## Town of Franklin

**DATE:** May 7, 2020  
**TO:** Franklin Planning Board  
**FROM:** Department of Planning and Community Development  
**RE:** 158 Grove Street  
Special Permit & Site Plan Modification

# SITE PLAN MODIFICATION 70, 72, 88 AND 94 EAST CENTRAL STREET

**Re: 70, 72, and 94 East Central Street  
Site Plan Peer Review Update**

SITE PLAN MODIFICATION  
CONSTRUCTION DETAIL PLAN - 3  
70, 72, 88 AND 94 EAST CENTRAL STREET  
FRANKLIN, MASSACHUSETTS  
PREPARED FOR  
70 EAST CENTRAL STREET, LLC  
37 EAST CENTRAL STREET  
FRANKLIN, MASSACHUSETTS  
MARCH 4, 2020  
SCALE: 1" = 20'

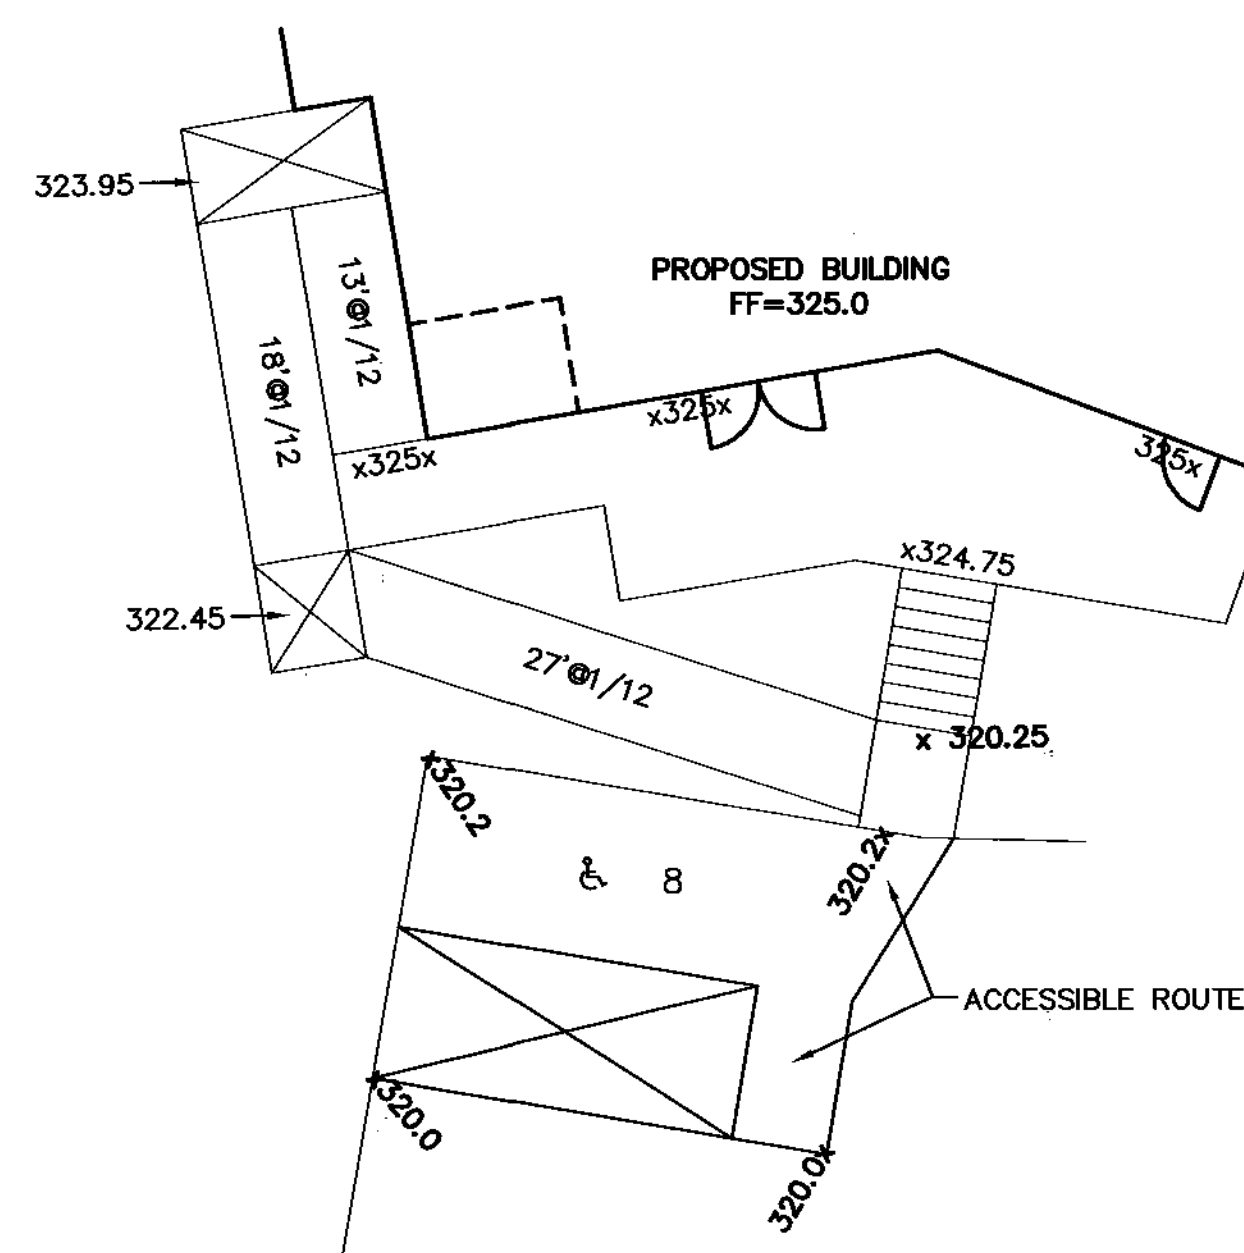
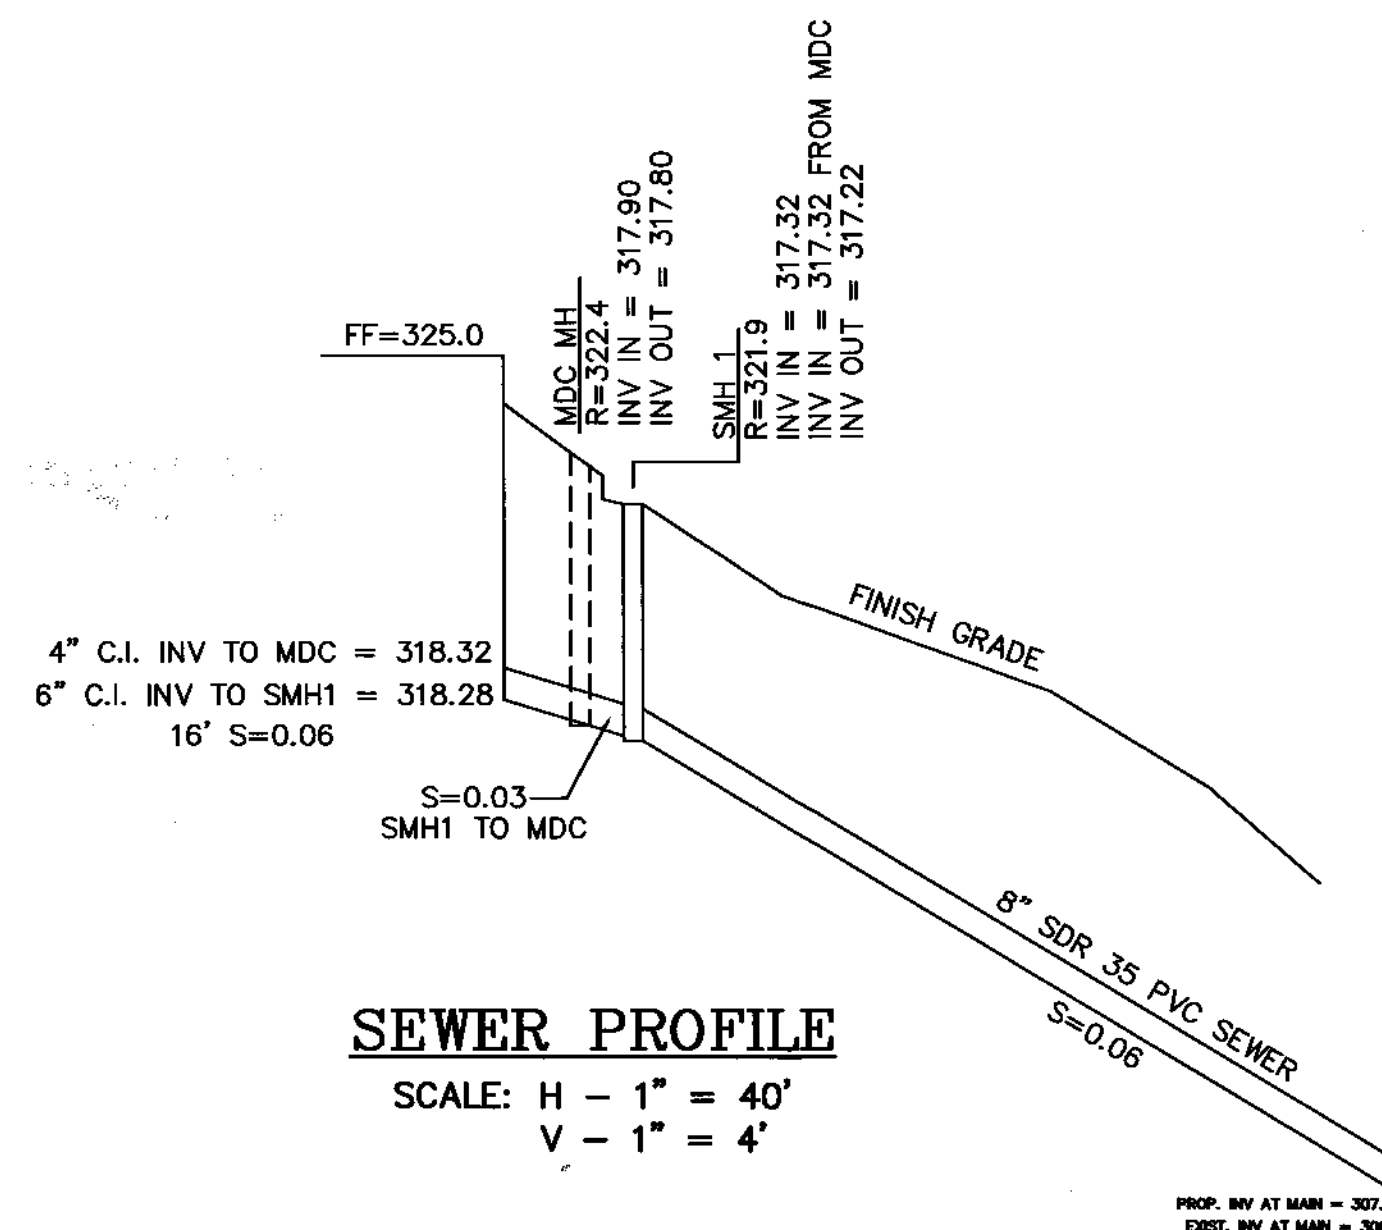
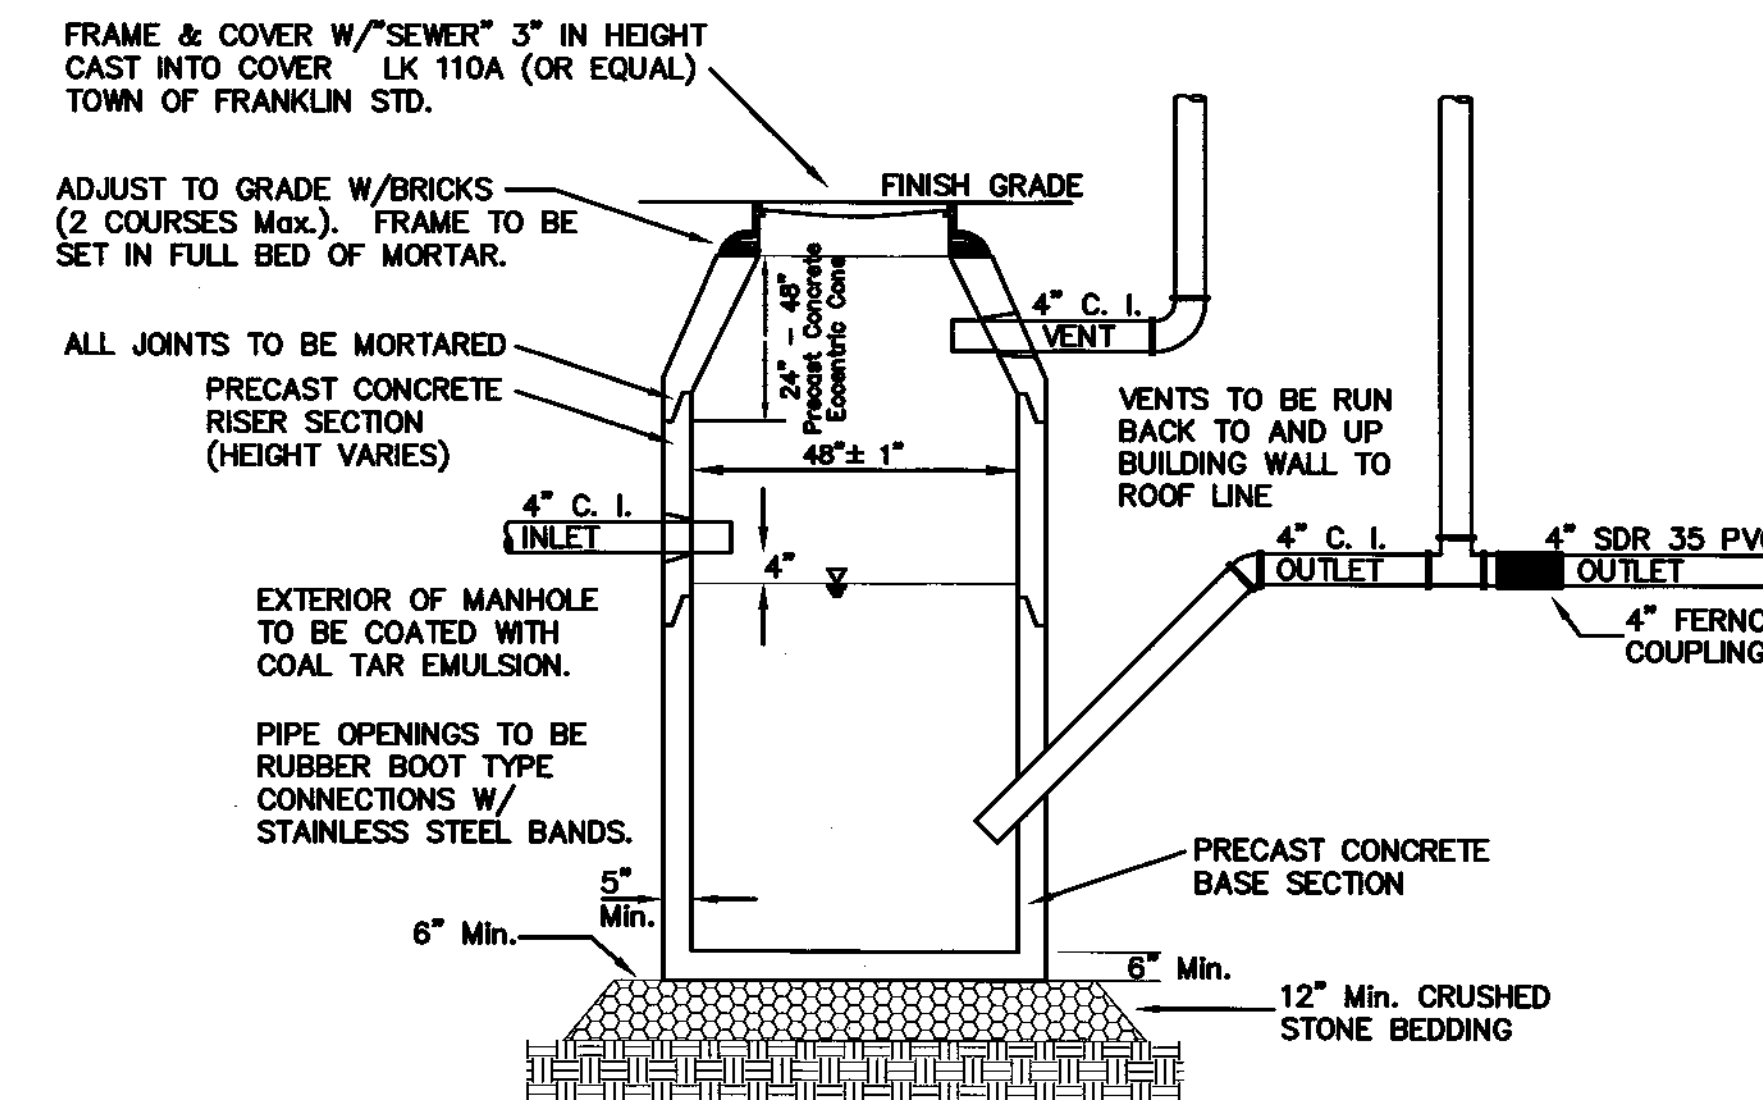
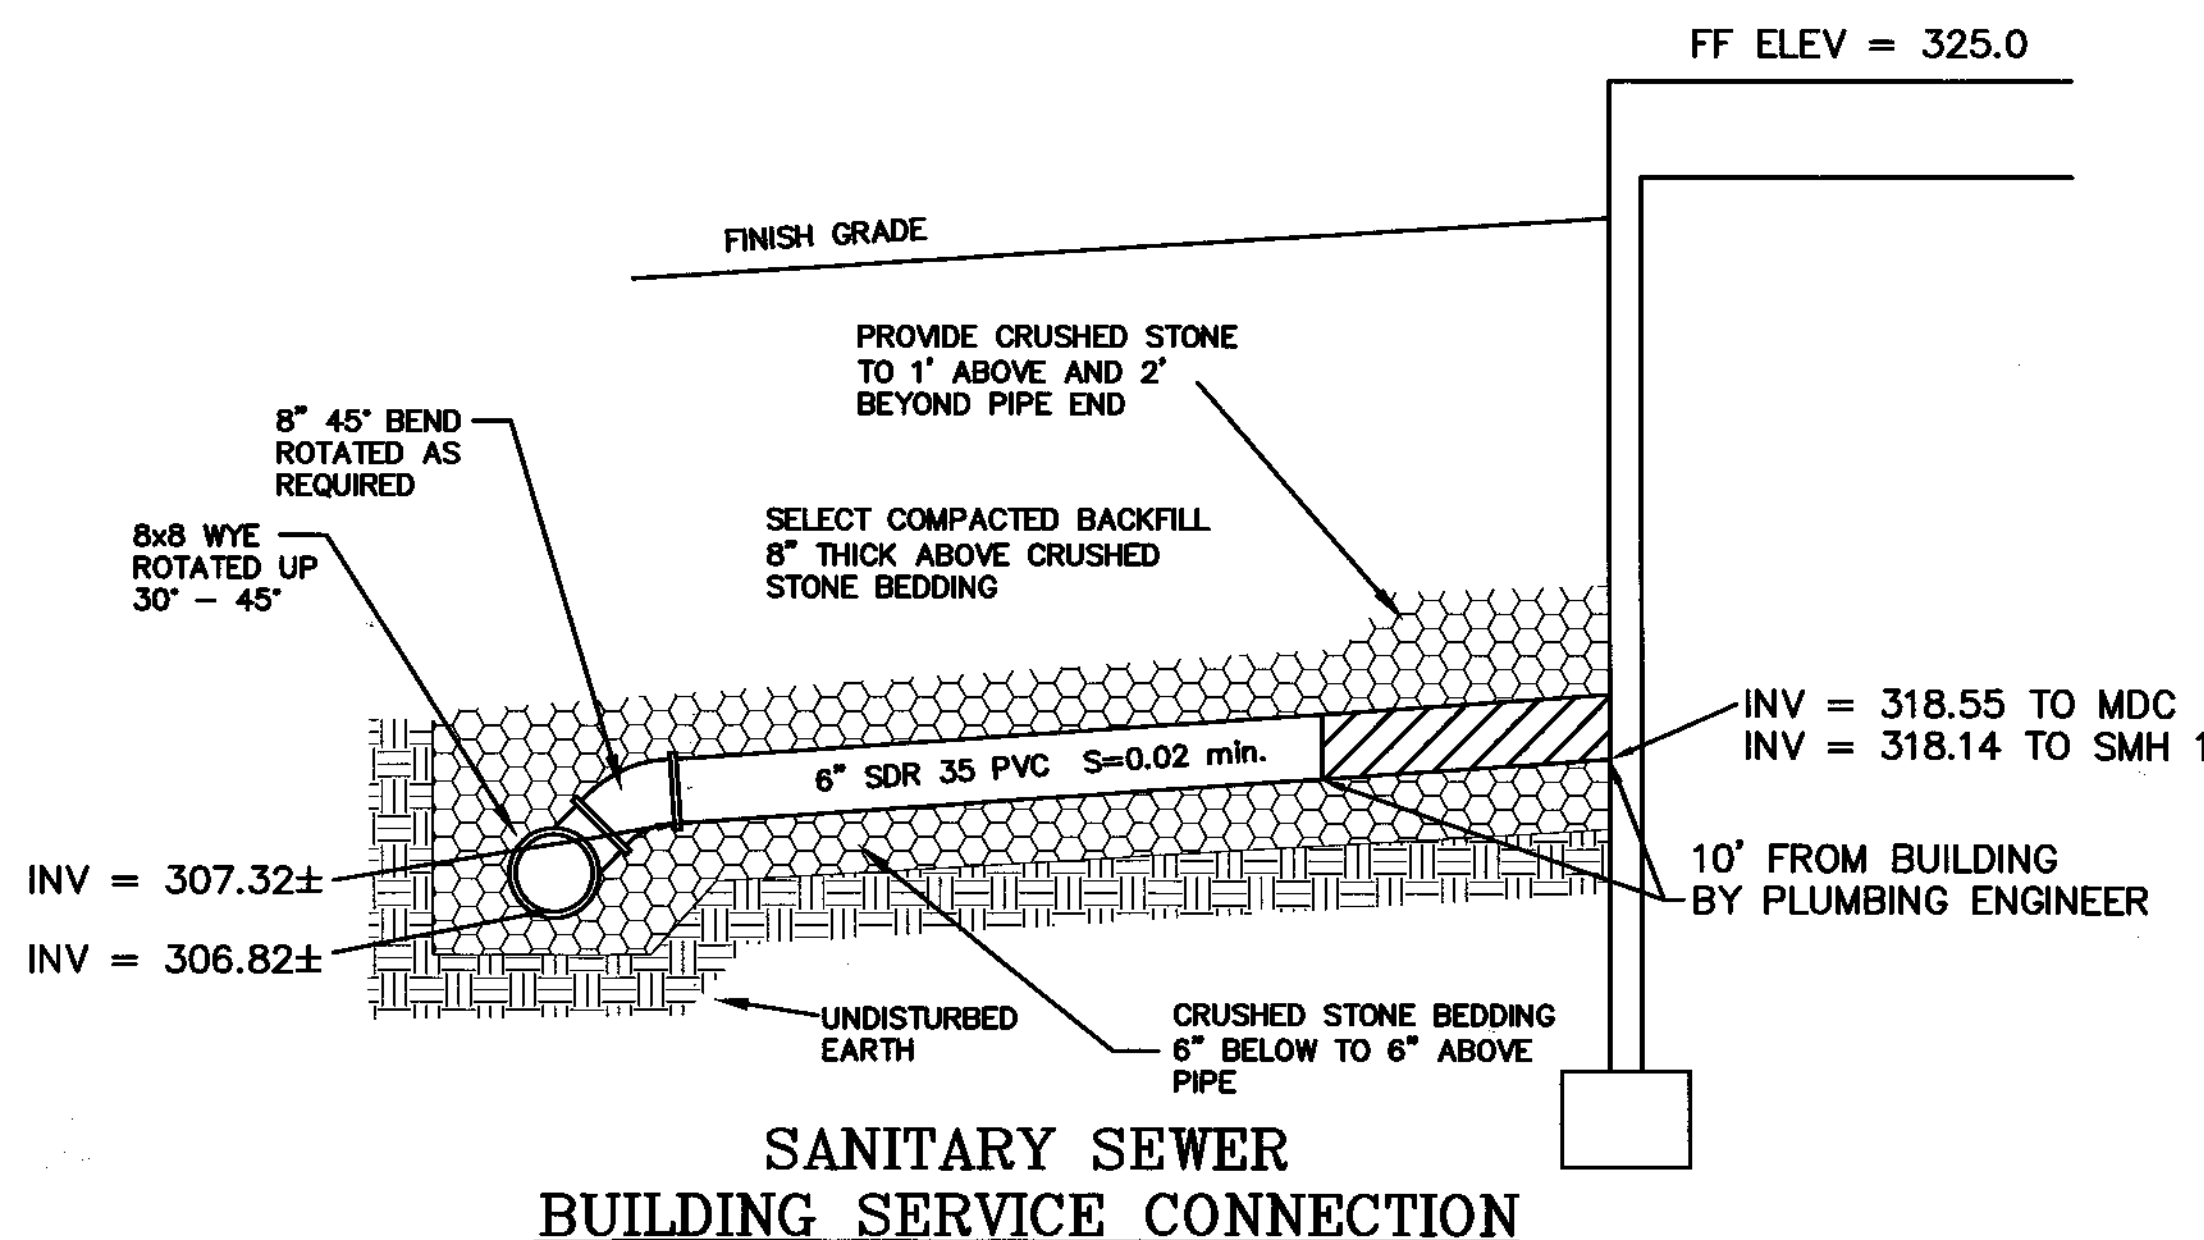
- P6. Note that handrails will be required along the accessible ramps. *UCI: A note has been added to the Accessible route detail on sheet 9. BETA2: Note provided – issue resolved.*

- P7. Confirm the proposed grade at the westerly door, shown as 226.0 on the accessible route detail. *UCI: The spot grade has been revised. BETA2: Grade revised – issue resolved.*
